**) Errol Gardens, Barnard Gardens and Belmont Avenue waiting
restrictions - Statutory Consultation**

Subject: Belmont Avenue, Errol Gardens and Barnard Gardens waiting restrictions statutory Consultation

Representations and Officer's Comments

Drawing No.	Z78-340-04
Revision	
Classification	CONSULTATION
Scale	1: 1250

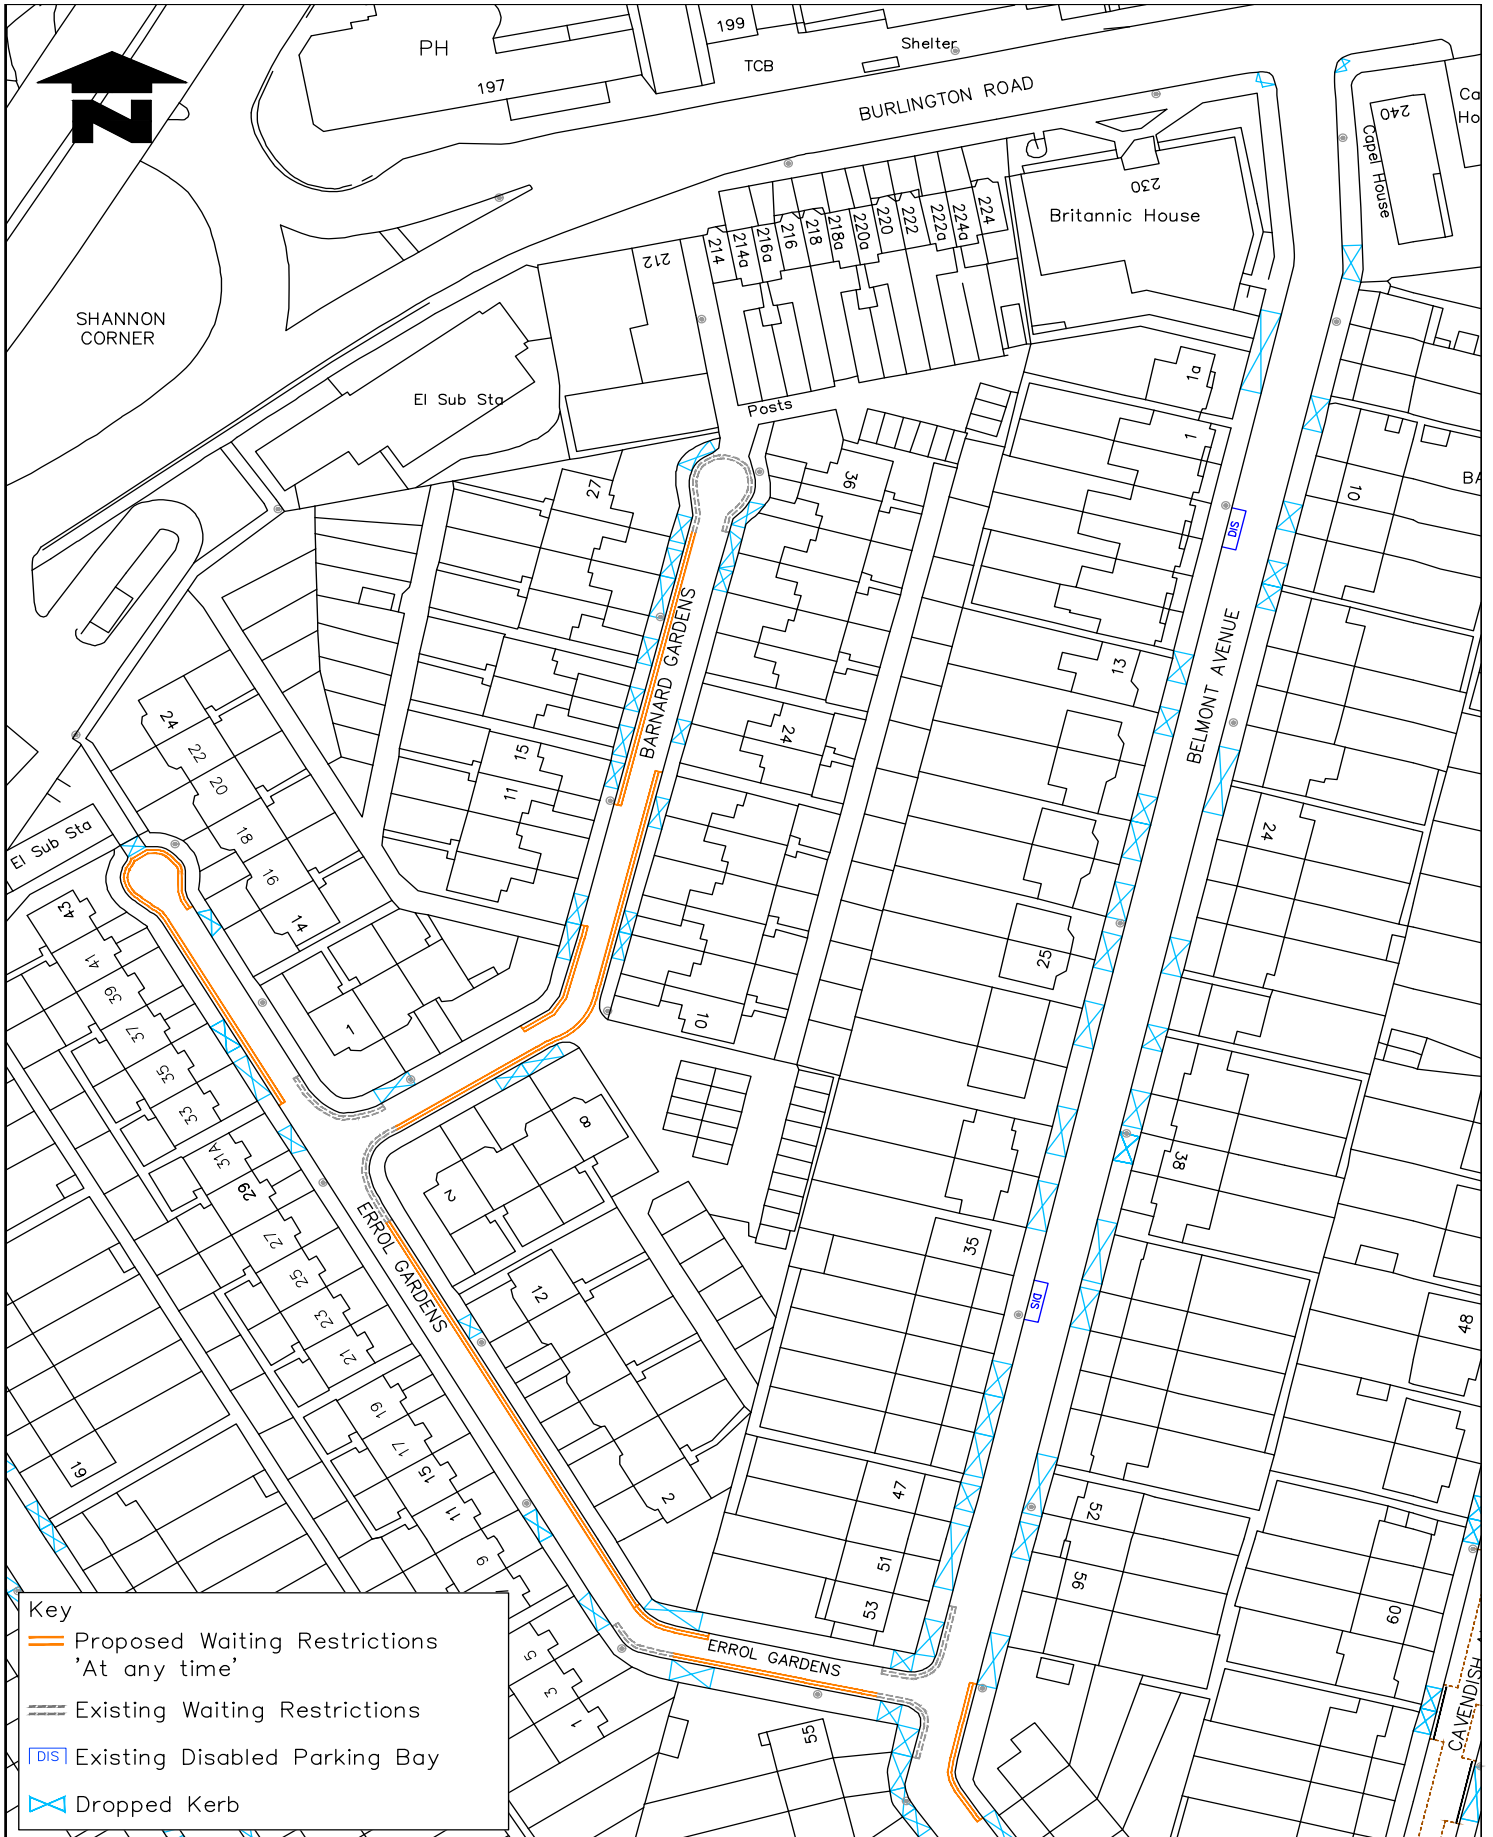
Please note that I do not oppose the proposition of double yellow lines – however, I do oppose the extent of them. I believe that the double yellow lines on Barnard Gardens should only be present on one side of the street, as opposed to the two sides (apart from where there is a bend). This would also mirror your propositions for Errol Gardens.

One good thing about the proposed waiting restrictions, is to put double yellow lines on the bend in Belmont Avenue between Nos 68/70. But I think the restriction should be extended to run between the dropped kerb at 56 and 70. This will give drivers a better zone of vision ahead as they approach to pass or turn in to Errol Gardens. I don't suppose you have any record, but I proposed this a long time ago.

- The positioning a length of the double yellow lines appears to be inefficient the length of the double yellow lines on Belmont avenue is longer than necessary to provide a motorist with sight along both sides of the bend. The length of the lines seems to be taken straight from a standard not taking into consideration reduced vehicle speeds due to it being a residential area. There are many curves/bends all over Merton and London that would fail the level of scrutiny applied here.

- The introduction of double yellow lines at the top of Errol Gardens where Errol Gardens meets Belmont Avenue seems over zealous in my opinion as the pavement on both sides of the road in this section of road is especially wide. Surely the council can review on kerb or partial on road parking on both sides of this section of road, especially as there are no homes opening on to this section of road.

Under the current proposed design, parking can only be permitted on one side of the road with double yellow lines on the opposite side. This will ensure vehicular access particularly for large vehicles, such as the emergency services at all times whilst also improving pedestrian safety, a concern raised by a number of residents during previous consultations.

Under the current proposed design, parking can only be permitted on one side of the road with double yellow lines on the opposite side. This will ensure vehicular access particularly for large vehicles, such as the emergency services at all times whilst also improving pedestrian safety, a concern raised by a number of residents.
